DESCRIPTION **Ltr notarized 5-21-76 requests for
amdt to Tech Specs & trans the following:**

PLANT NAME: Duane Arnold Plant

PROPOSED CHANGE RTS-66A TO DAEC TECHNICAL SPECIFICATIONS

II. Proposed Changes in Technical Specifications

Figure 3.6-1 Change in Charpy V Transition Temperature Versus Neutron Exposure

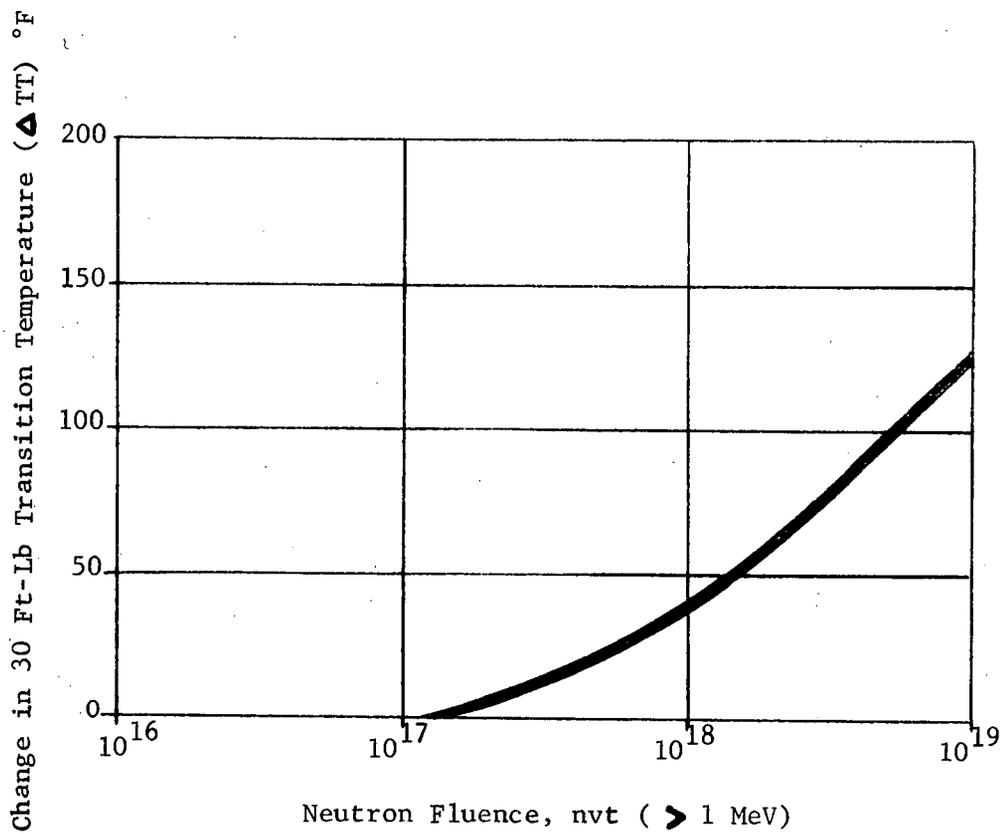
Delete the present Specification 3.6.A and 4.6.A (Limiting Conditions for Operations, Surveillance Requirements and Bases for Thermal and Pressurization Limitations) including Table 3.6-1 and Figure 3.6-1.

Replace with the attached Specification 3.6.A and 4.6.A, including Figures 3.6-1, 3.6-2A, 3.6-2B and 3.6-2C.

General Electric recommendations for making this periodic adjustment include the application of the shift curve, Figure 2, from NEDO-10115 (Figure 3.6-1 of the proposed Technical Specifications), Upper Limit for 550°F GE BWR Operating Experience. Until the estimated neutron fluence at the 1/4 thickness points discussed above reaches 3×10^{17} , there should be no need to make any adjustments to the beltline operating limit curves.

A relationship between neutron fluence and change in Charpy V, 30 foot pound transition temperature has been developed for SA302B/SA533 steel based on at least 35 experimental data points as shown in Figure 3.6-1. In turn, this change in transition temperature can be related to a change in the temperature ordinate shown in Figure G 2110-1 in Appendix G of Section III of the Boiler Code.

Figure 3.6-2A Minimum Temperature for Pressure Tests

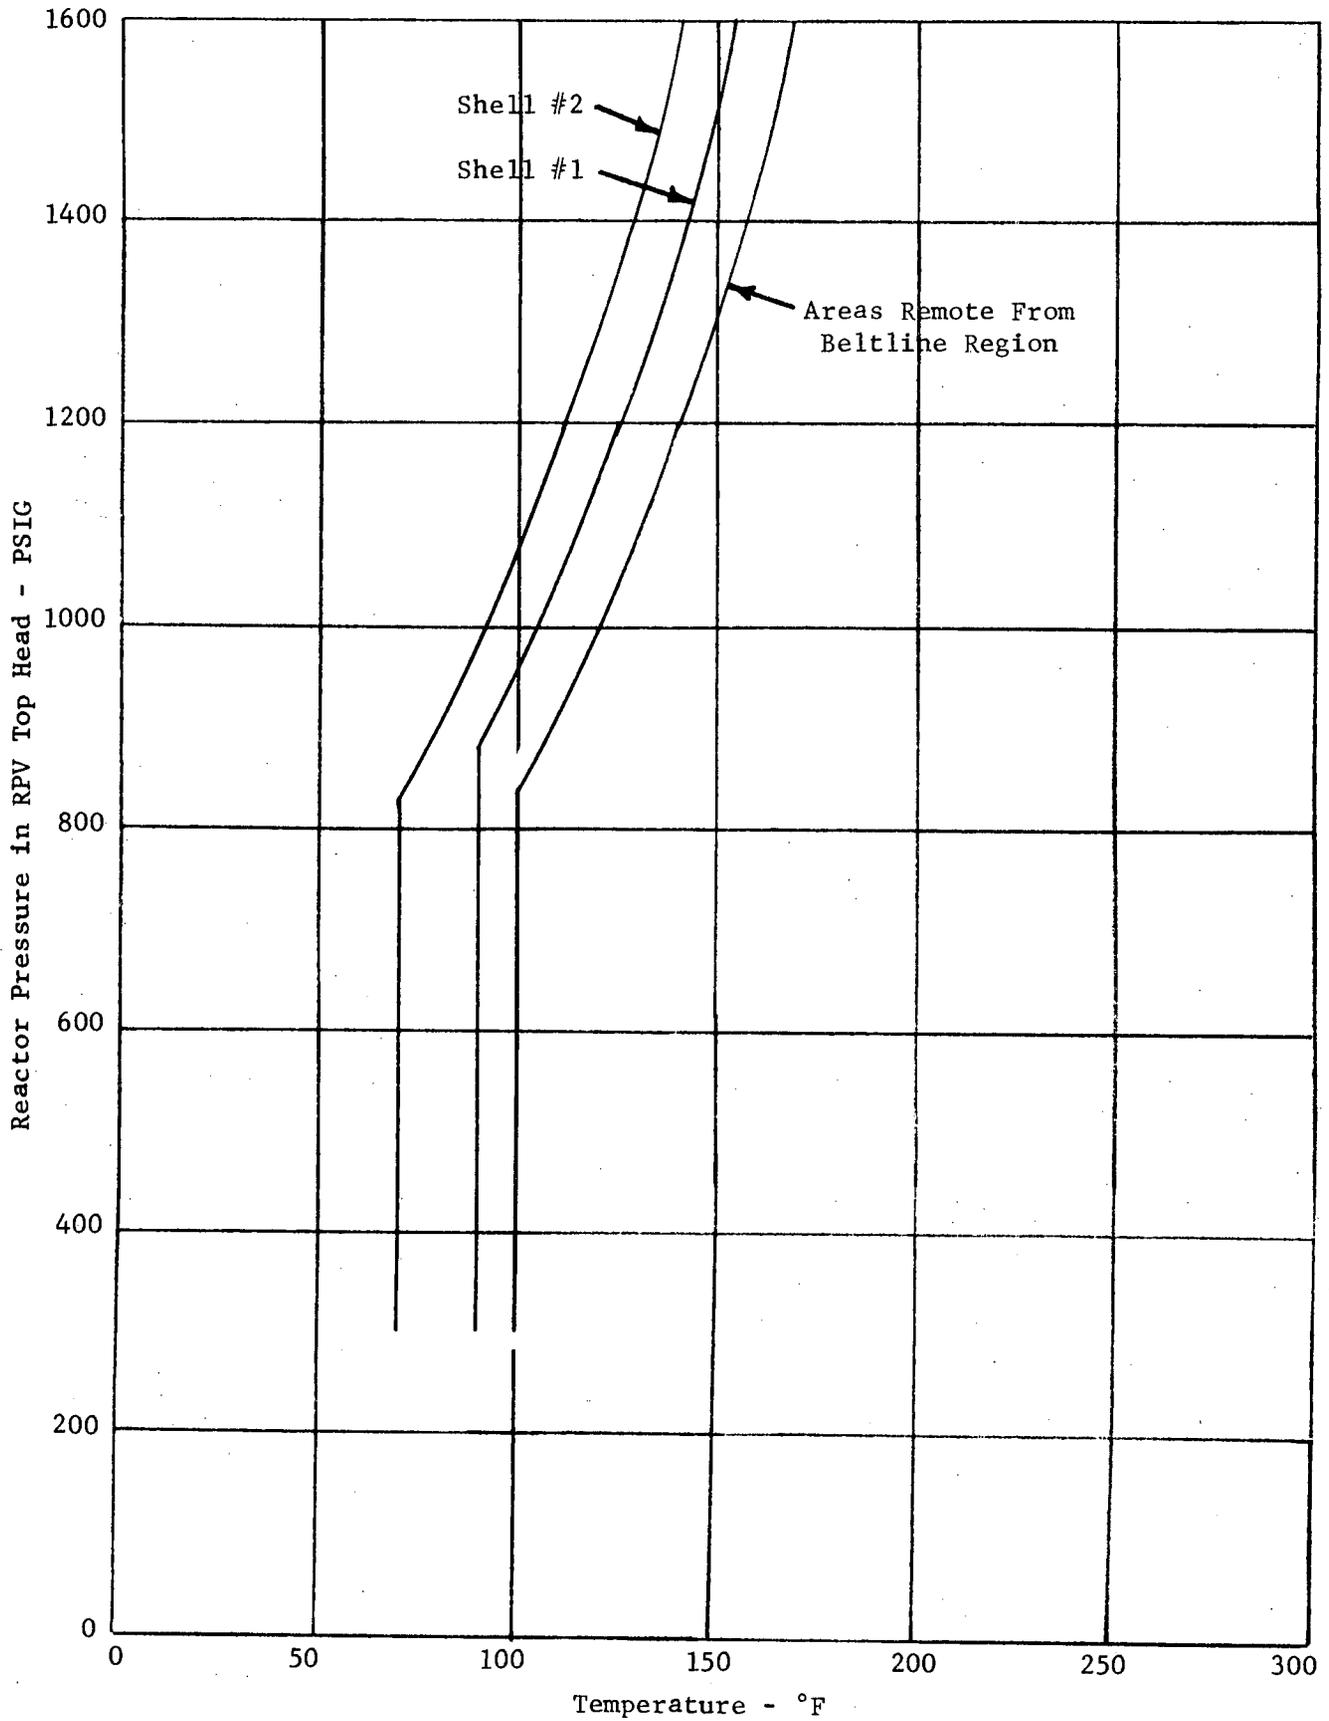
Operating limits on RPV pressure and temperature during normal heatup and cooldown, and during inservice hydrostatic testing, were established using Appendix G to the ASME Boiler and Pressure Vessel Code, Section III, 1971 (Appendix G was first added in the Summer 1972 Addenda) as a guide (see Figures 3.6-2A, B and C of the proposed Technical Specifications). These operating limits will ensure that a large postulated surface flaw, having a depth of one-quarter of the material thickness, can be safely accommodated in regions of the RPV shell remote from discontinuities.

2. The reactor vessel shell temperatures during inservice hydrostatic or leak testing shall be at or above the highest of the temperatures shown on the curves of Figure 3.6.2A where the RPV shell beltline region curves are increased by the expected shift in RT_{NDT} from Figure 3.6-1.

Figure 3.6-2C Minimum Temperature for Criticality

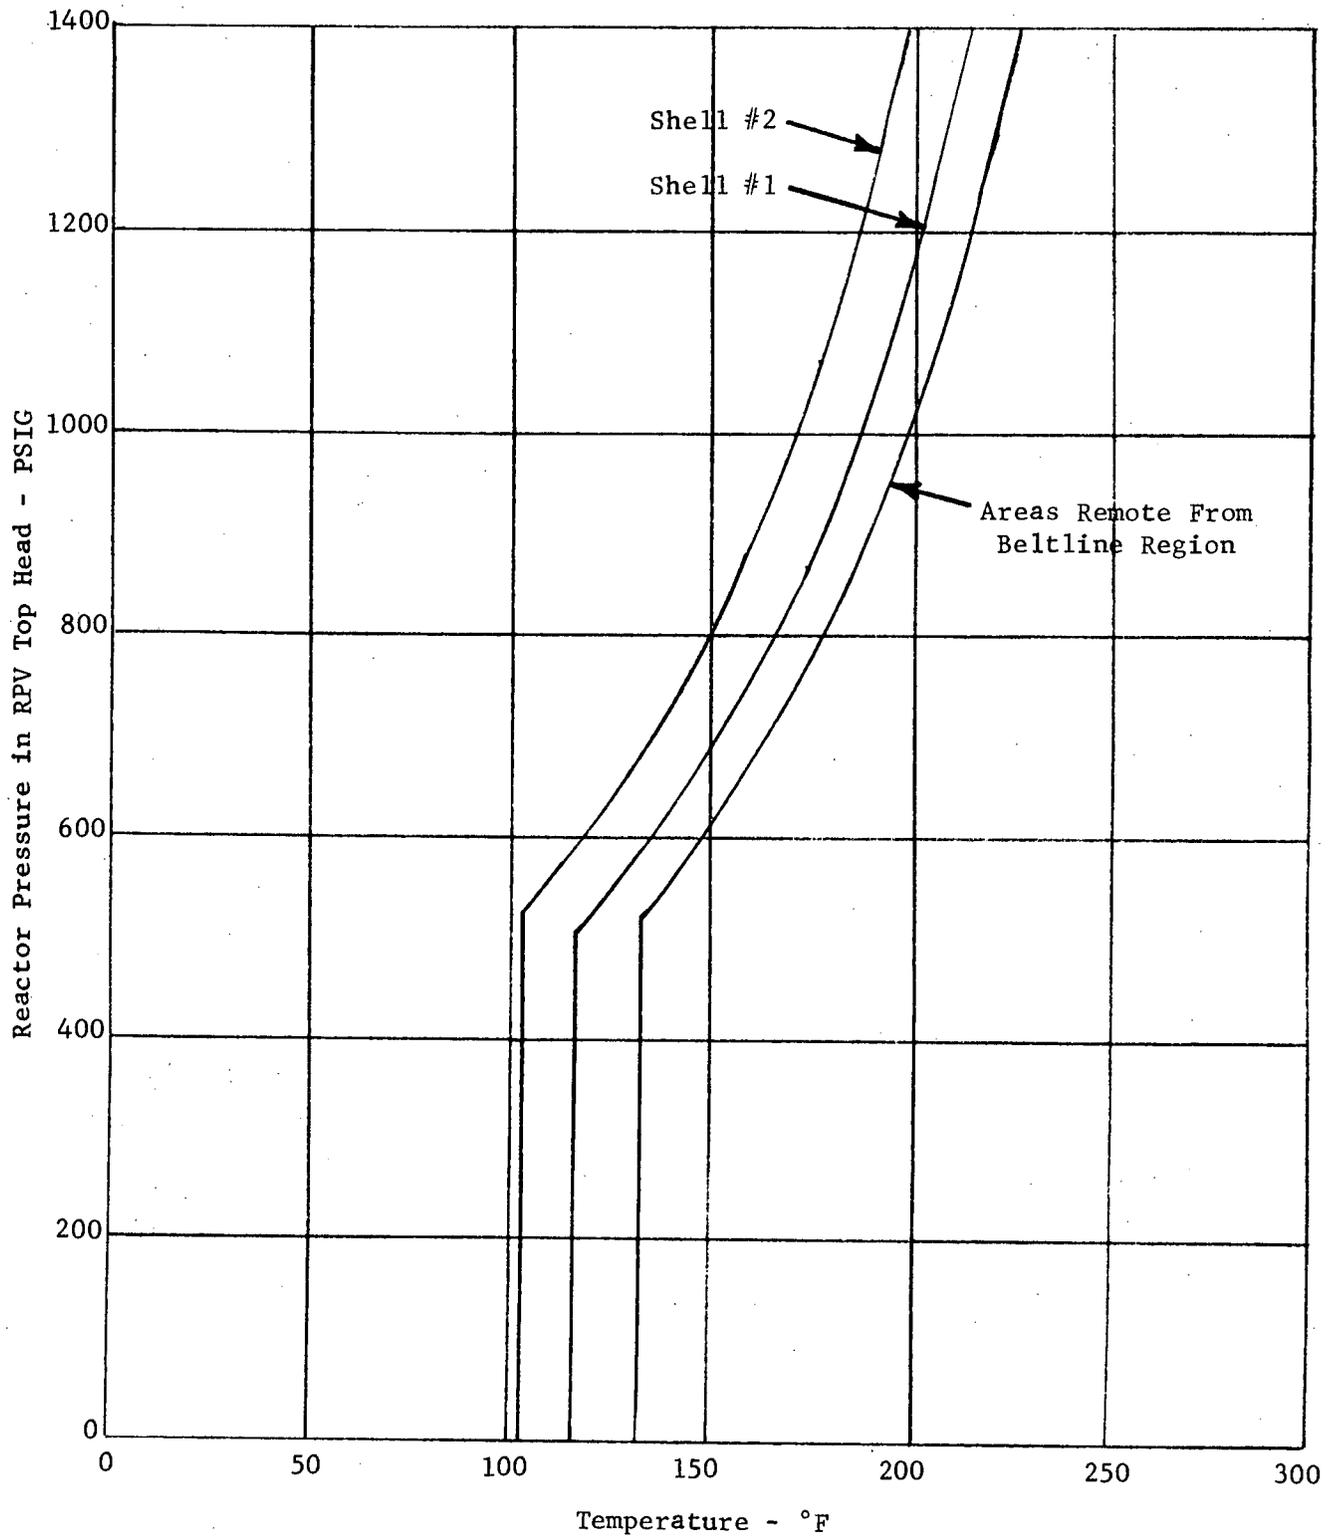
core operation show by vertical lines that no core operation is permitted below the minimum temperature for an 1100 psig ISI hydrostatic test. The enclosed proposed Technical Specifications illustrate the use of the operating limits.

During all operation with a critical core, other than for low level physics tests, the reactor vessel shell and fluid temperatures of 4.6.A.1 shall be at or above the highest of the temperatures of Figure 3.6-2C where the RPV beltline curves are increased by the expected shift in RT_{NDT} from Figure 3.6-1.
